Access Compliance Report

Public Rights-of-Way

Intersection ID: 47611	Main Street: WYALONG_DR	Cross Street: MINTWORTH_AV	Location: SE
ADA ID: 3D534E6C38FC	Ramp Type: Perp	Initial Pass/Fail: Fail	Overall Compliance: No
		Severity Score: 12.5

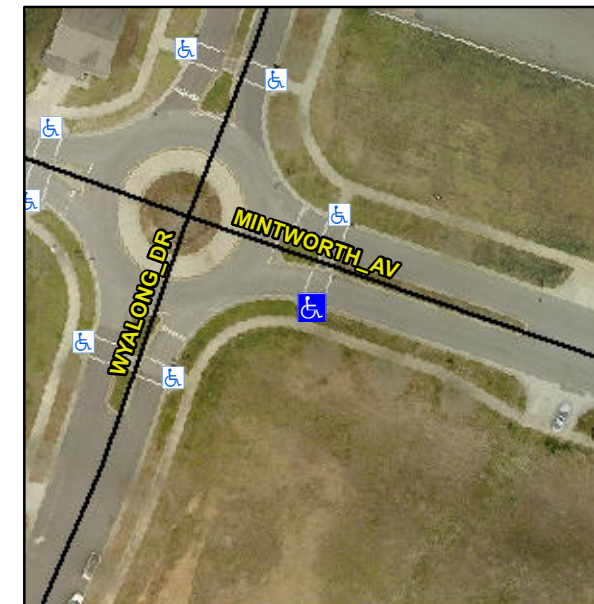
R304.2.2

Compliance	Description	Data	Compliance	Description	Data
N/A	Ramp Length (in)	96.0	No	Ramp Slope (%)	9.3
Yes	Ramp Width (in)	69.0	Yes	Ramp XSlope (%)	1.6
N/A	Flare Type LT	N/A	N/A	Flare Type RT	N/A
N/A	Flare Slope LT (%)	N/A	N/A	Flare Slope RT (%)	N/A
N/A	Flare Traversable LT?	N/A	N/A	Flare Traversable RT?	N/A
N/A	Landing Length (in)	N/A	N/A	DWS Provided?	N/A
N/A	Landing Width (in)	N/A	N/A	DWS Contrast?	N/A
N/A	Landing Slope (%)	N/A	N/A	DWS Length (in)	N/A
N/A	Landing X Slope (%)	N/A	N/A	DWS Full Width?	N/A
N/A	Landing Curb? (Y/N)	N/A	N/A	DWS Offset (in)	N/A
N/A	Shared Landing?	N/A			
N/A	Gutter Ponding?	N/A	N/A	Gutter Slope (%)	N/A
N/A	Gutter Lip Ht (in)	N/A	N/A	Gutter X Slope (%)	N/A
N/A	Painted X Walk1?	Yes	N/A	Painted X Walk2?	N/A
	X Walk 1 Direction	To NE		X Walk 2 Direction	N/A
N/A	X Walk 1 Width (in)	119.0	N/A	X Walk 2 Width (in)	N/A
	X Walk 1 Slope (%)	4.1		X Walk 2 Slope (%)	N/A
	X Walk 1 X Slope (%)	0.8		X Walk 2 X Slope (%)	N/A

Remove & Replace Entire Ramp.
